# **Clause 49 State Diagrams**

**IEEE 802.3az, New Orleans, January 2009**

Figure 49-14—Transmit state diagram

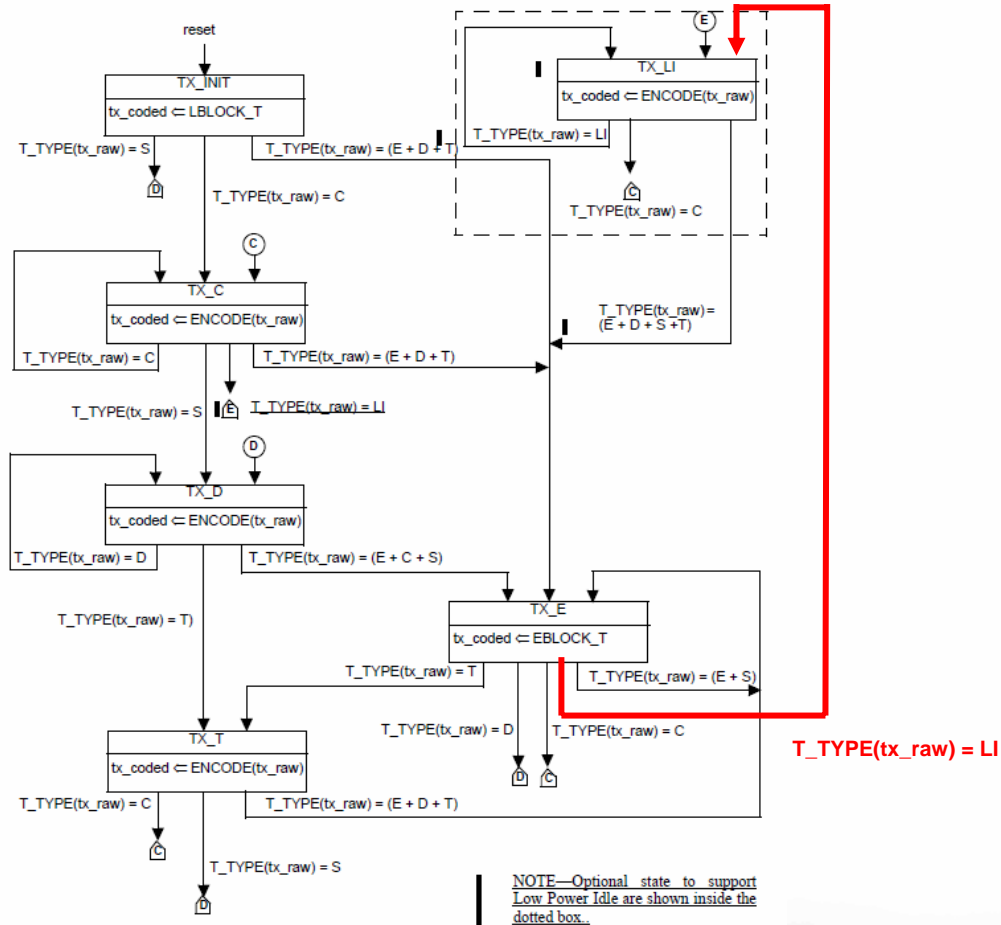
- The Clause 49.2.13.2.3 Function definition for R\_BLOCK\_TYPE and T\_BLOCK\_TYPE for C needs to be revised.
- The Clause 49 Transmit State Diagram has a state transition from TX\_LI to TX\_E. There needs to be a transition from TX\_E back to TX\_LI to recover from an error condition during Low Power Idle.
- The Clause 49 Receive State Diagram has a state transition from RX\_LI to RX\_E. There needs to be a transition from RX\_E back to RX\_LI to recover from an error condition during Low Power Idle.
- This presentation proposes these changes to the function definitions, Transmit and Receive State Diagrams.
